Elk Rock Estates

Natural Resource Review, Willamette Greenway Review, Variances

Master File #NR-2018-005 (with WG-2018-001, VR-2018-014, VR-2018-015, LC-2018-001)

Planning Commission
July 23, 2019
Presentation by Vera Kolias, Associate Planner

Proposed:

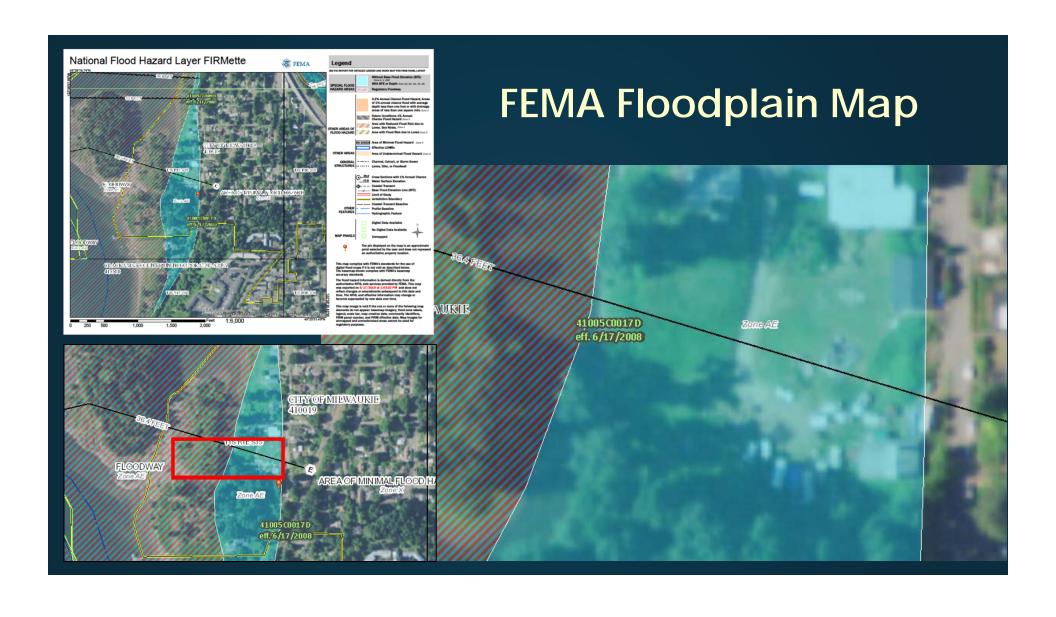
- 1. Cut and fill analyses not provided for Metro 1996 flood area
- Bankful stage not identified
- Non FEMA reviewed study to allow nonstandard use of crawlspace and enclosed areas below base flood elevation
- 4. Drainage impacts on neighboring properties
- 5. Design of detention area to avoid fish being trapped during high flow events

The applicant is comparing the FEMA NAVD flood elevation to the 1996 NGVD flood elevation without making the appropriate datum conversion.

The FEMA Base Flood Elevation (BFE) is 36.4' NAVD 88

The 1996 Flood Elevation in Milwaukie City Code is 37.978' NAVD 88 (which comes from the referenced elevation in the code 34.5' NGVD 29 converted to NAVD 88 using NOAA VERTCON).

Therefore, the design flood height should be the 1996 flood elevation = 38.0' NAVD 88.

Approval Criteria - Alternatives Analysis

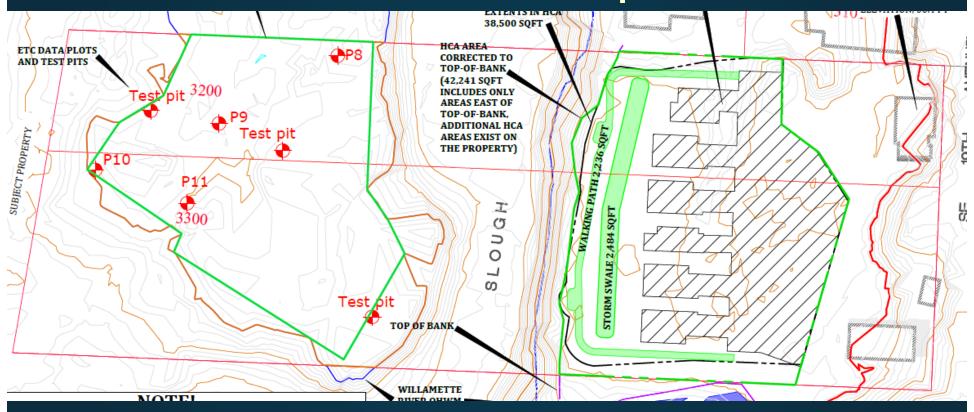
Would fewer units, such as 9 units clustered at the street as shown in Alternative #2, be a viable project?

Proposed Mitigation Area

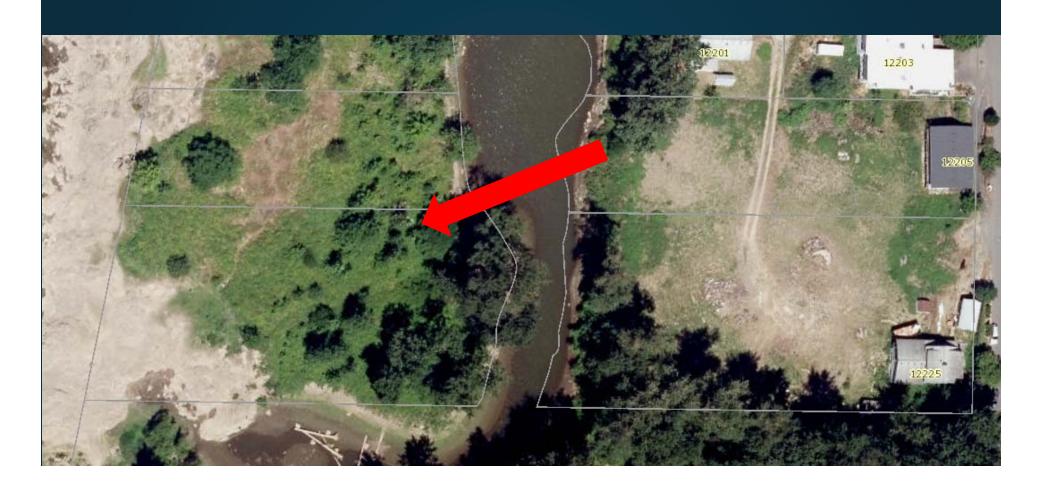
- 1. Is there an alternative that provides 12 units that are built closer to 19th Ave, that provides parking from below, and that are clustered as much as possible away from the HCA and the floodplain?
- 2. Is the proposed mitigation area appropriate given its propensity to flood and its current natural state?
